Mercedes-Benz

Campaign No. 2020090004, September 2020

SUBJECT: **Model 907 (Sprinter), Model Year 2019**  
Chassis 3.88t

D32.35-A003-79

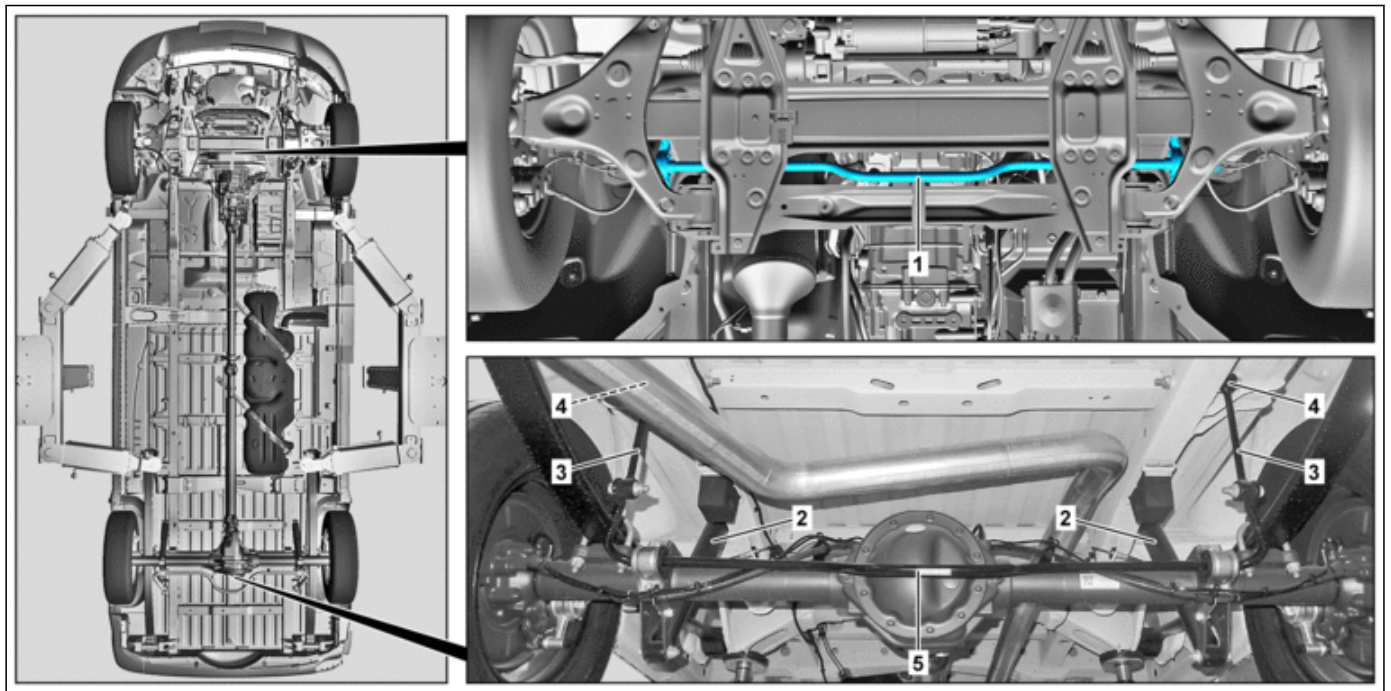
| 1 | Front anti-roll bar    | 4 | Bolts           |
| 2 | Shock absorber         | 5 | Rear stabilizer |
| 3 | Stabilizer bar linkage |   |                 |

<b>Check</b>		
1	Check if vehicle is affected by measure.	 For authorized Mercedes-Benz service partners, only the entry in the "Extended VEGA Application" (EVA) system, in the "Current" tab, is decisive. An additional test of the affected vehicles in the workshop information system (WIS) or vehicle list is thereby not necessary.	
	<b>Remove/install</b>		
2 	Replace front torsion bar linkages.	 Do not yet attach the lower nuts of the torsion bar linkages.	AR32.35-D-3330TS
3 	Replace front stabilizer (1).	Model 907 except code ZG1 (engageable all-wheel drive) except code ZG3 (engageable all-wheel drive with gear reduction)	AR32.35-D-2050TS
4 	Replace rear shock absorbers (2).		AR32.25-D-0110TS
5	Attach rear torsion bar linkages (3) to the longitudinal member.	 Guide screws (4) through the longitudinal member. Attach and tighten nuts. Counterhold screws (4).  Bolt, torsion bar linkage to longitudinal member	<a href="#">BA32.35-N-1002-03TS</a>

6 	Install rear stabilizer (5).		AR32.35-D-2210TS
7	Enter special equipment into on-line vehicle data card.	 Designation of affected special equipment: code CB7 (Stage I stabilization)  Remove existing code CB1 (suspension for comfort and sensitive loads).
